21 00790 AS Land between Woodchurch Road and Appledore Road Tenterden, Kent

Arboricultural and landscape comments.

- **T381 Ancient Field Maple. (F10)**

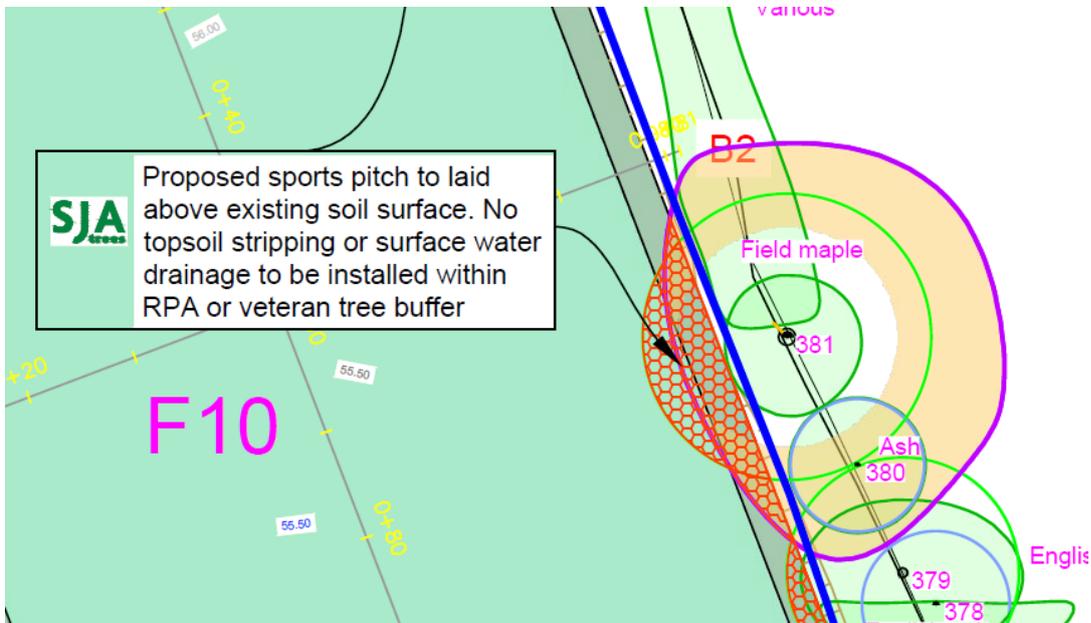
Recent examination shows a silted ditch to the E aspect (much as the ditch adjacent to T312). The morphing of the Buffer Zone to the E may be an approach that is flawed owing to the likely root morphology having preference to the W. With an adjusted Buffer Zone that reflected the likely root morphology, both the raising of soil levels and the excavation for drainage would have a significant impact on the Buffer Zone area – this may be seen as contrary to NPPF para 175 (c) as a 'deterioration'.

The application shows a football pitch proposed within the offset Buffer Zone for T381 and an incursion within the RPA.

During the Tree Officer’s site visit of 08 07 2021 it was noted that a silted ditch was visible at a lower level to the east of the stool, this will have been a long established historic boundary feature that has not been cleaned out recently.

The ditch as a historic feature is likely to have had some bearing on the rooting morphology as a barrier to some extent, and a buffer zone and RPA being offset by some degree to the west not the east is an evidenced response to the feature.

It is noted that not only would the soil level be raised by the pitch run off zone and probably the pitch itself within a reconfigured buffer zone and RPA, but incursions are shown even within the offset to the east buffer zone of the proposal shown in TPP excerpt 1 above. In addition, excavation is planned for within T381 to install drainage for the pitch. This level of incursion is unacceptable as BS5837:2012 recommends that no development should occur within the RPA of any ancient or veteran tree, in my view, drainage excavation is development and would likely result in a deterioration to the rooting area of the ancient tree.

Furthermore, as has been highlighted, the ditch will have likely had an effect on the rooting morphology of T381 and with an appropriately offset RPA and buffer zone to the west aspect the incursions would be even greater and of a magnitude that should not be reasonably countenanced.

As per the NE/FC Standing Advice relating to veteran and ancient trees, the buffer zone of an ancient tree should be a semi-natural habitat, short mown grass would not accord with the Standing Advice as a semi-natural habitat

The Tree Officer objects to the developmental incursions within T381 and the application of the offset buffer zone as this will likely result in a deterioration to the ancient tree – this is contrary to 2021 NPPF para 180 (c). Furthermore the buffer zone would not be a semi-natural habitat and contrary to the NE/FC Standing Advice on Veteran and Ancient Trees.
